From: Ray, Phillip M [pmray@tva.gov]
Sent: Tuesday, September 23, 2008 8:35 AM
To: Joseph Sebrosky
Cc: Sterdis, Andrea Lynn
Subject: RAI Response
Attachments: BLN RAI Response to RAI Letter 101 draft 20080919 redline pmr.doc; Attachment_2.5.4-6A_Figure_2.5-314.pdf; Attachment_2.5.4-6B_Figure_2.5-348a.pdf; Attachment_2.5.4-6C_Figure_2.5-348b.pdf

BELLEVILLE COMBINED LICENSE APPLICATION – RESPONSE TO REQUEST FOR
ADDITIONAL INFORMATION – STABILITY OF SUBSURFACE MATERIALS AND
FOUNDATIONS

Reference: Letter from Ravindra G. Joshi (NRC) to Andrea L. Sturgis (TVA), Request for
Additional Information Letter No. 101 Related to SRP Section 2.5.4 for the
Belleville Units 3 and 4 Combined License Application, dated August 5, 2008

Figure 1
Vertical limits of excavation, Bellefonte Nuclear Plant, Unit 3 (from FSAR Figure 2.5-348a)

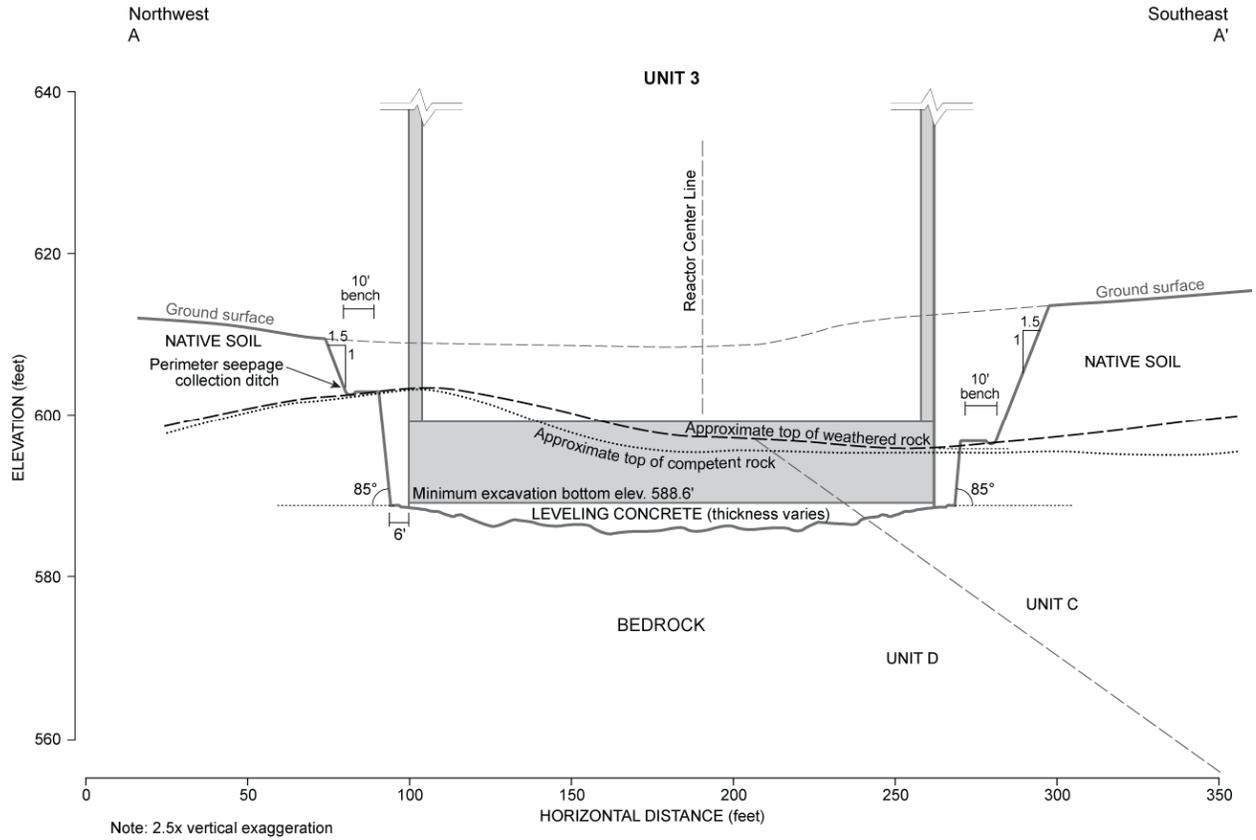
AP1000 DCD (Rev.16) has site criteria for the lateral variability of the foundation supporting soils. Geologic units inside the Middle Stones River Formation demonstrate different geotechnical properties. For example, FSAR Figure 2.5-299 shows a sharp contrast between Units C and D in terms of their shear wave velocities. Due to the inclining layering at the site, different geologic units will appear beneath the same reactor foundation. For example, Middle Stones River Unit C will support the eastern part of the Unit 3 foundation and Unit D will support the western half of the foundation. Please explain if this subsurface lateral variability meets the minimum requirement of the AP 1000 DCD site criteria on lateral variability. Furthermore, please explain if the inclined geologic boundaries beneath the foundation basemat will affect the surface ground motion estimates and possibly introduce a seismic force concentration.

The Unit 3 foundation will consist of a relatively thin (1 to 5 ft) layer of leveling concrete emplaced on rock Units C and D (See Figure 1 of Attachment 02.05.04-05A). The leveling concrete will have a shear wave velocity comparable to the lower velocity Unit C which is less than the shear-wave velocity of Unit D.

The Unit 3 foundation velocity structure produced by the dipping strata and the layer of fill concrete consists of two distinct velocities, Unit D with a shear-wave velocity of 10,000 fps, denoted V2, and Unit C and the fill concrete, both with a shear-wave velocity of 6500 fps, denoted V1. This value for V1 is selected to correspond to the lowest plausible mean estimate of V1 consistent with Figure 2 shown in Attachment 02.05.04-05A to obtain the most conservative estimate of the potential influence of V1 on site response and potential seismic force concentrations. These distinct shear-wave velocity regions always have the lower velocity material, V1, located above the higher velocity material, V2. Separating the two velocity units is a nearly flat interface between Unit D and the fill concrete under the western portion of the Unit 3 foundation and a 15 degree east-dipping interface between Units C and D beneath the eastern part of the Unit 3 foundation (shown in Figure 1 of Attachment 02.05.04-05A).

The maximum combined thickness of Unit C and the fill concrete between the basemat and Unit D at the eastern limit of the basemat is about h=12 ft. (see Figure 1 of Attachment 02.05.04-05A). The minimum resonance frequency associated with amplification occurs at the eastern limit of the basemat corresponding to the maximum value of h. The minimum resonance frequency associated with amplification is $f=V1/(4*h)=135$ Hz, using the quarter wavelength approximation (Boore and Brown, 1998; eqns. 2 and 5)(Reference 1). Consequently, any amplification associated with the lower-velocity Unit C portion of the basemat will occur at frequencies greater than 100 Hz, which exceeds the maximum frequency considered in probabilistic seismic hazard analyses (NRC Regulatory Guide 1.208, Page 7, last paragraph).

Calculation Geometry, Input Parameters, and Results for Three SH-Wave Incident Angles

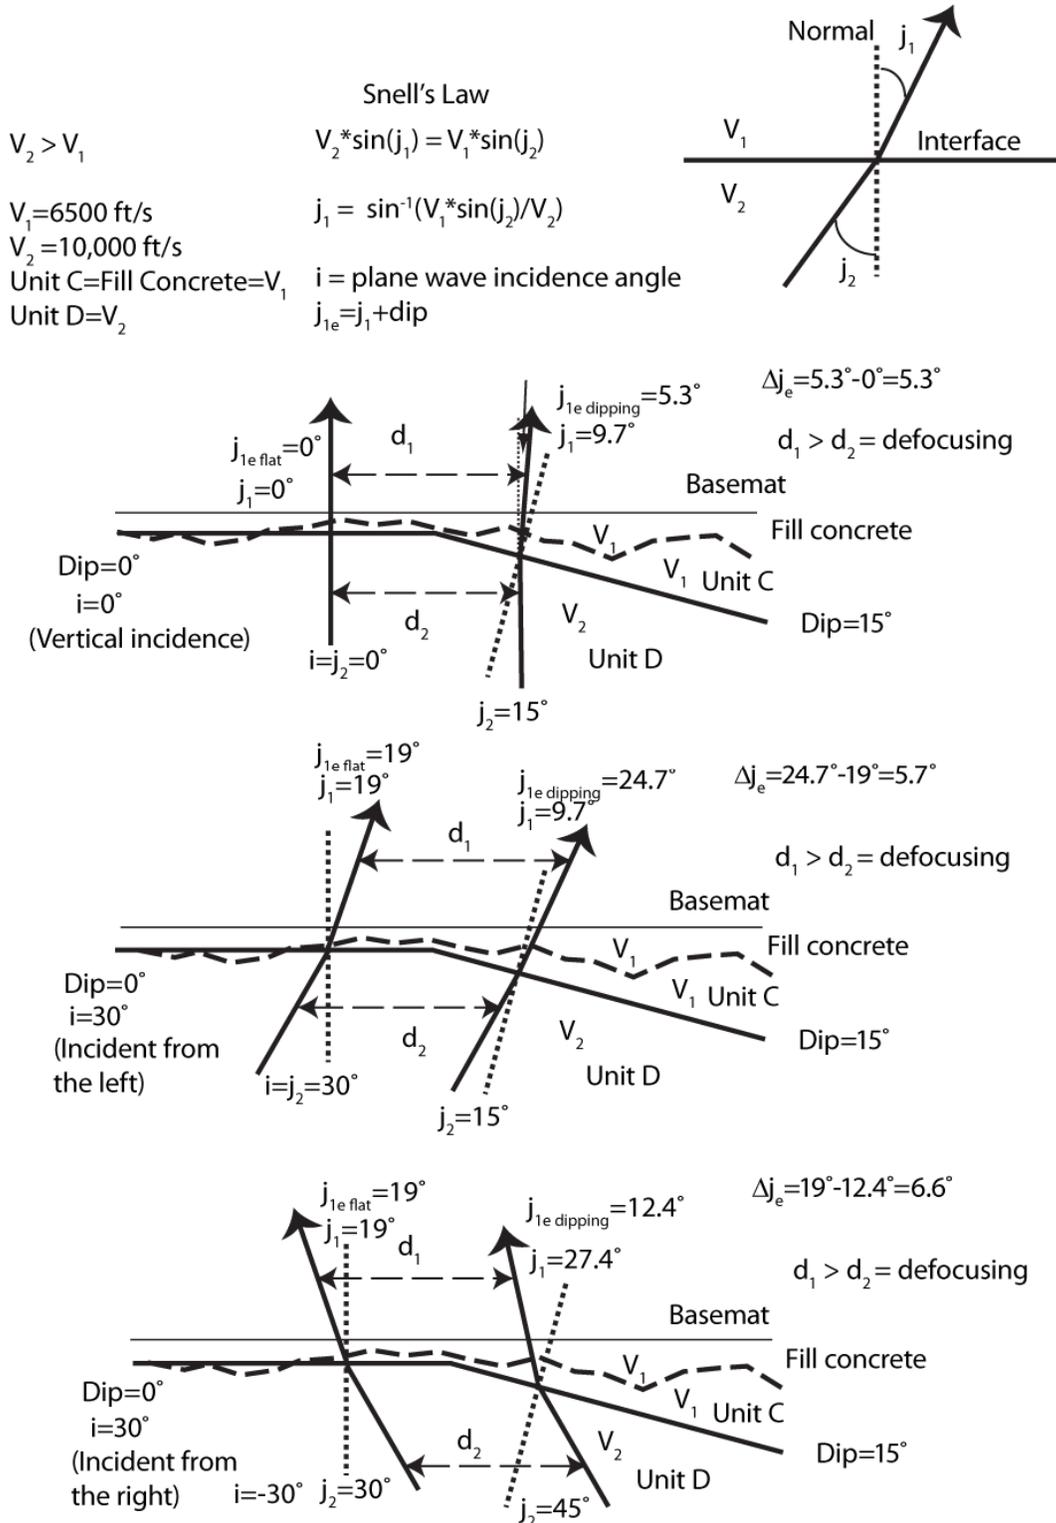
The second part of the question asks if inclined geologic boundaries beneath the foundation basemat will affect the surface ground motion estimates and possibly introduce a seismic force concentration. To answer this question, the potential for surface ground motion amplification associated with lower-velocity Unit C and the fill concrete is first evaluated and then the possibility of a force concentration associated with the inclined geologic boundaries beneath the foundation basemat is evaluated.

The velocity structure beneath Unit 3 approximates a plano-concave lens that diverges collimated incident waves, in this case incident SH-waves. The qualitative effect of the dipping strata beneath Unit 3 is to defocus seismic forces in the foundation basemat where the dipping interface intersects the fill concrete. The velocity structure does not produce a convergence (focusing) of seismic forces in any other portion of the foundation. Snell's law is used to demonstrate that ray divergence in the fill concrete and Unit C near the intersection of the dipping interface with the fill concrete is never less than 5.3 degrees for the angles of incidence associated with incident shear waves (Figures 3 and 4 of Attachment 02.05.04-05A). The only systematic influence of the dipping strata beneath Unit 3 is to locally decrease seismic forces in the

Horizontal Pressure on Walls from Compaction Effort

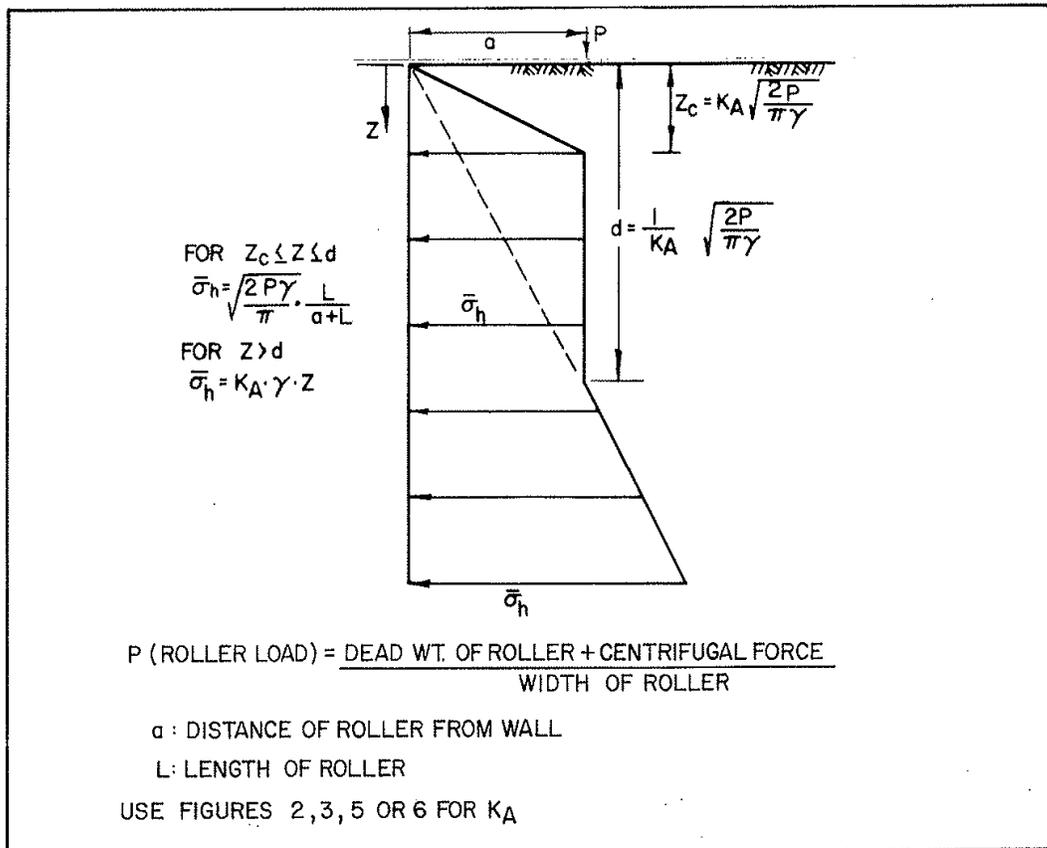
As requested in the RAI, compaction-induced loads acting on the exterior walls of the nuclear islands were evaluated. The added loads caused by compaction are a function of the weight of the compactor, the type (static or vibratory), the distance it is operated from the wall and the soil types. A method for evaluating the lateral earth pressures on a wall due to the earth and the compaction equipment is given in Figure 13 of NAVFAC DM 7.2 (Reference 1). A copy of the referenced figure is included in Attachment 02.05.04-14A. Another method for calculating the lateral earth pressures to incorporate stresses from compaction is presented in a paper by Duncan et al. (Reference 2). A comparison of both methods found that the NAVFAC method yields slightly higher pressures for the same distance from the wall, so the NAVFAC method was used for the evaluation.

A summary of typical self-propelled drum compactors is contained in Reference 2. Review of the listed compactors shows the one producing the greatest total force is a Dynapac Model CA30 with a total force of 70.6 kips, a drum width of 84 inches and a wheelbase of 113 inches. Using the NAVFAC methodology, stresses for this compactor operating at distances from the wall varying from 1 foot to 5 feet were compared to stresses calculated at the same depth using the static at-rest earth pressure calculated from FSAR Figure 2.5-360, assuming no water table is present. The comparison showed that keeping the compactor at least five feet away from the wall, as is stated in FSAR Subsection 2.5.4.10.5,

will keep stresses on the wall due to the compaction equipment at a negligible level. Therefore, no adjustment to the recommended lateral earth pressure for static, at-rest conditions is needed. FSAR Figure 2.5-360 does not need revision in response to this RAI.

Revised Figure 2.5.4-360

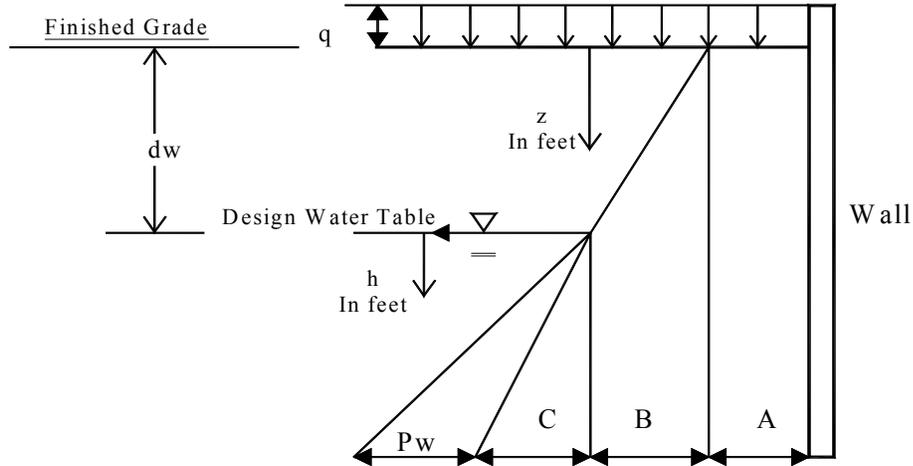
FSAR Section 2.5.4.10.5 states that the earth pressure coefficients for the at-rest and passive conditions determined using the methods described in Reference 462 are illustrated in FSAR Figures 2.5-360 and 2.5-361. FSAR Figure 2.5-360 shows the distribution of earth pressures from the soil backfill (at-rest condition), and, below the water table, the additional pressure caused by the hydrostatic pressure. FSAR Figure 2.5-361 shows the soil passive pressure distribution. No hydrostatic pressure is included in the passive pressure because water has no shear strength and provides no additional passive resistance. Since the hydrostatic associated pressure also contributes to the lateral pressure applied to the nuclear island walls, excluding the hydrostatic pressure from the passive, at-rest, or active earth pressure evaluation is not justified. Please include the hydrostatic pressure into passive or at-rest earth pressure evaluation and revise the contents of FSAR Figs. 2.5-360 and 2.5-361, accordingly.

Discussions with NRC technical staff have clarified that inclusion of the hydrostatic pressure in the at-rest and passive earth pressure diagrams is appropriate for the nuclear island basement walls. The FSAR text and Figures 2.5.4-360 and 2.5.4-361 will be revised as described below in a future revision of the COLA.

Earth pressure coefficients for the at-rest and passive conditions determined using the methods described in Reference 462 are illustrated in Figures 2.5-360 and 2.5-361. Figure 2.5-360 shows the distribution of earth pressure from the soil backfill (at-rest condition), and, below the water table, the additional pressure caused by hydrostatic pressure. Figure 2.5-361 shows the soil passive earth pressure distribution, including the additional pressure caused by hydrostatic pressure below the water table.

2. COLA Part 2, FSAR Chapter 2, Figure 2.5.4-360 will be revised as indicated in Attachment 02.05.04-21A.

FIGURE 2.5-314
 Elevation Contour Map of Top of Competent Rock – Units 3 & 4

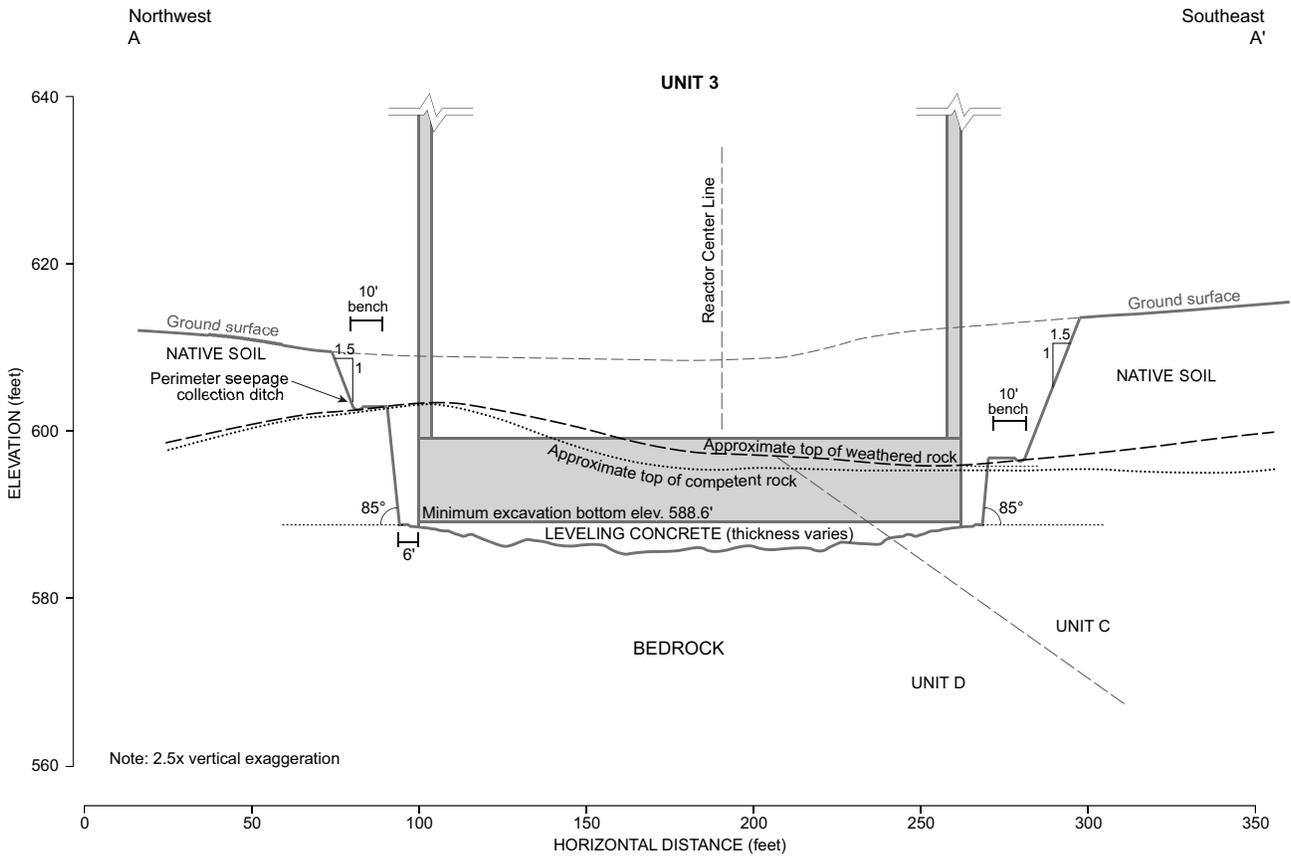
Based on seismic reflection profiles, FSAR Section 2.5.4.1.3.3 presents P-wave velocity (V_p) contours for two surfaces at 6000 and 14000 ft/sec, respectively (in FSAR Figures 2.5-312 and 313). You also implemented P-S suspension logging to measure the P wave velocity profiles at various borehole locations. Please provide a comparison of the wave velocity profiles obtained from these two different methods. Are these methods consistent in terms of P wave velocity measurements? FSAR Figure 2.5-339 shows a site stratigraphic profile across the site, including borehole locations and corresponding shear wave velocity profiles, as well as Units 3 and 4 foundation profiles. The figure demonstrates that the Unit 3 foundation excavation is located inside the bedrock with a shear wave velocity about 9000 fps and a P wave velocity of about 16000 fps. FSAR Figure 2.5-314, however, shows a large area underneath Unit 3 where the top of the 14000 fps (V_p) layer is below elevation 588.6 ft. Please explain the discrepancy.

The discrepancy between estimates to top of competent rock defined by the depth to a P-wave velocity of 14,000 fps based on seismic refraction measurements in FSAR Figure 2.5-314 and the estimates of depth to top of competent rock defined in FSAR Figure 2.5-339 based on borehole data are the results of several systematic factors in the acquisition, analysis, and interpretation of the seismic refraction data that tend to introduce a bias to overestimate refractor depths.

The cumulative effects of all refractor depth estimation biases is sufficient to explain the tendency of Figure 2.5-314, based on seismic refraction analyses of depth to refractor, to overestimate depths to top of rock by 0-20 ft relative to FSAR Figure 2.5-339, which is based on borehole data. Consequently, the most appropriate definition of depth to competent rock should be based on borehole data and actual conditions revealed during excavation, not on the seismic refraction data.

4. COLA Part 2, FSAR Chapter 2, Figure 2.5-314 will be revised as presented in Attachment 02.05.04-06A.
